PITTSBURGH WATER AND SEWER AUTHORITY

**RE: Water and Sewer Availability  
911 Pretense Way and 908 PJ McArdle Roadway – 15146**

# Calculations for McArdle Townhomes Sewage Facilities Planning Module

PENN-OHIO GROUP  
 McARDLE TOWN HOMES  
 911 PRETENSE WAY & 908 PJ McARDLE ROADWAY  
 CITY OF PITTSBURGH - 17TH WARD  
 ALLEGHENY COUNTY

PROJECT NO:	1697
SCALE:	AS SHOWN
DATE:	1/2/2019
DESIGNED BY:	ZSM
DRAWN BY:	MJN
CHECKED BY:	RLS
SHEET TITLE:	TAP-IN PLAN
SHEET NO.	TP1.1

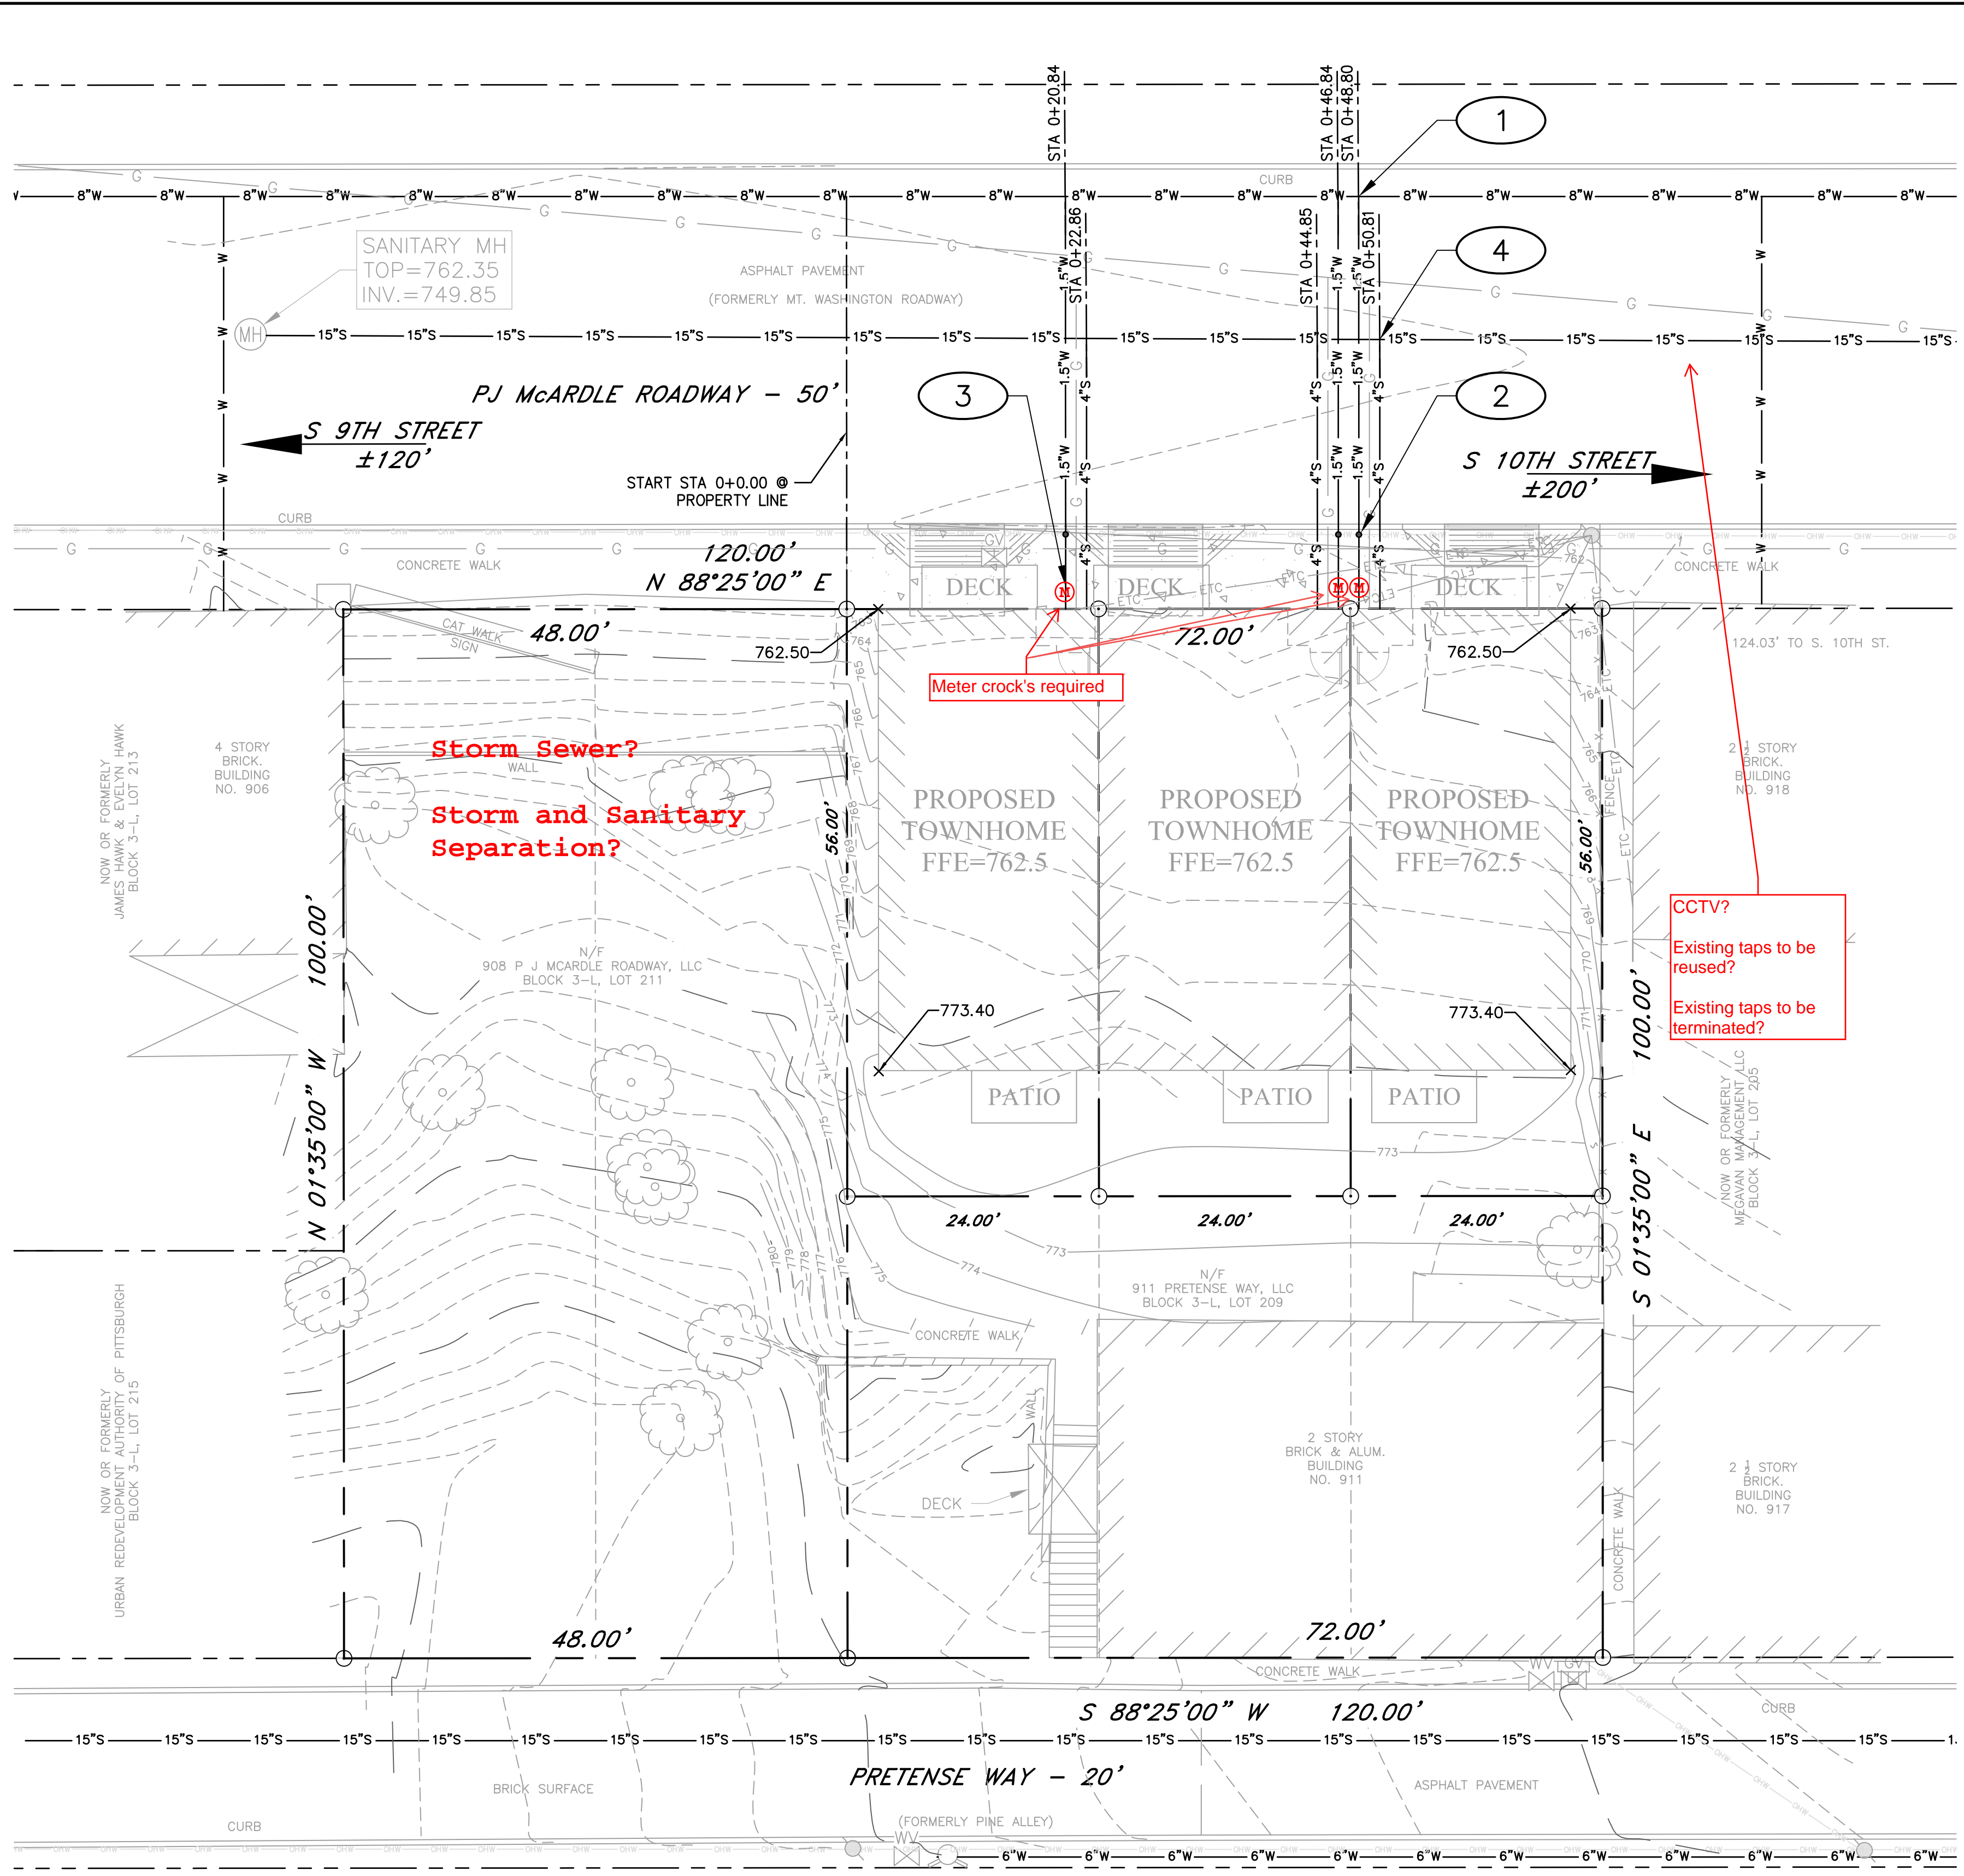
4. There is no mention of a storm sewer on the plans. Prior to connecting to PWSA Combination sewer line, sewer lateral should be separated (see PWSA detail ST-5).
